ADDENDUM NO. 3

Reference: Student Activity Center Addition to the Stromberg Athletic Complex
Weber State University – Ogden, Utah
DFCM Project No. 12031810

Addendum 003

project:	WSU Stromberg Student Activity Center	**project no:**	12475
date:	2012-10-18	**no. pages:**	77
owner:	DFCM		
contractor:			
bid date:	2012-11-01	**bid time:**	12:00 pm

1 LEVEL 01 OVERALL - ELECTRICAL
1/16" = 1'-0"

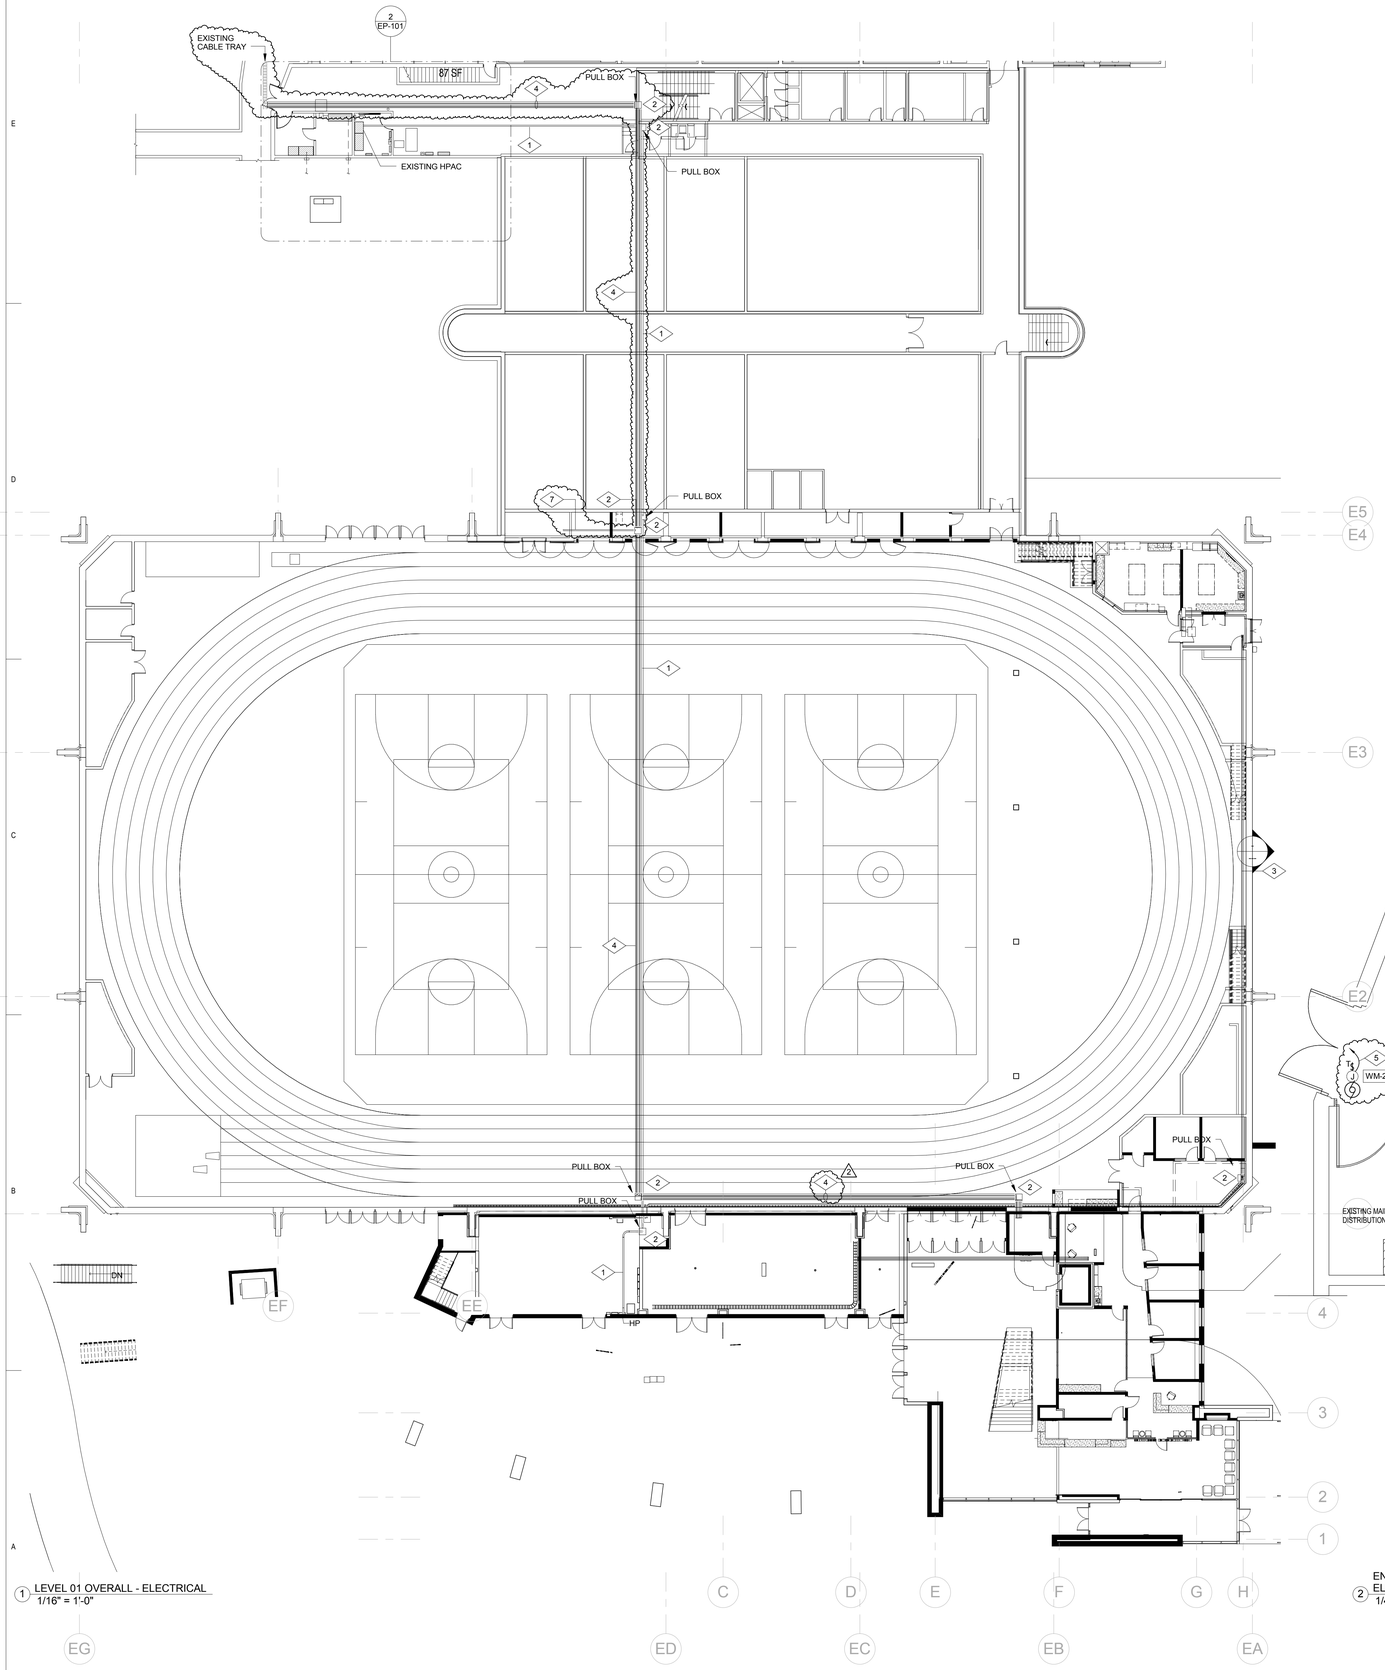
2. Reference note 1, change 3-1/2" conduit to two (2)3" conduits.
3. Provide 120V. power to water meter "WM-2". See note #5 for more information.
4. Reference note # 4 has been modified. See revised drawings for more information.
5. Communications conduit referenced in note #4 now runs to the existing cable tray by the existing main electrical room. See revised drawings for more information.
6. Run one (1) 3" conduit from the existing communications room to the pull box shown. See revised drawings and note #7 for more information.
